COMMONWEALTH OF VIRGINIA
COUNTY OF HENRICO

RE: POD2022-00639
 The Hillside
 Concept Plan Review Comments

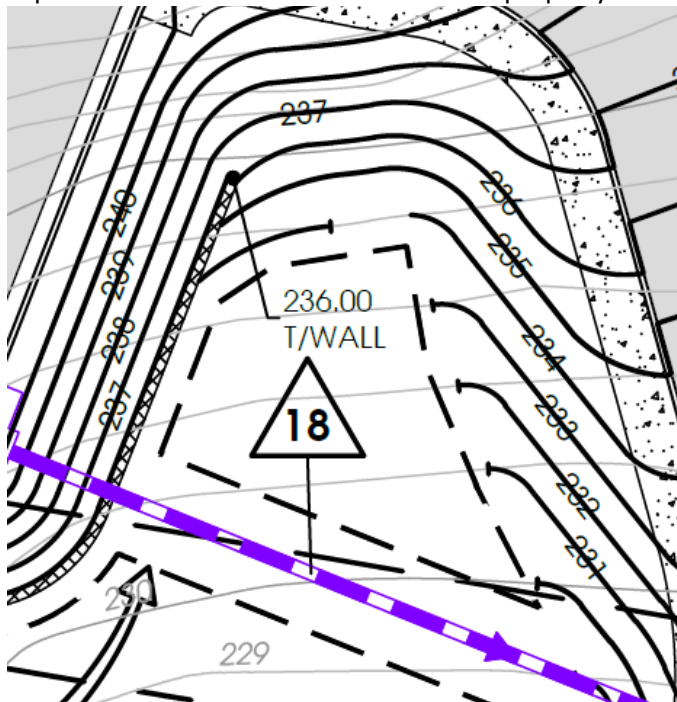
12. The striped area shown below must be curbed and landscaped.
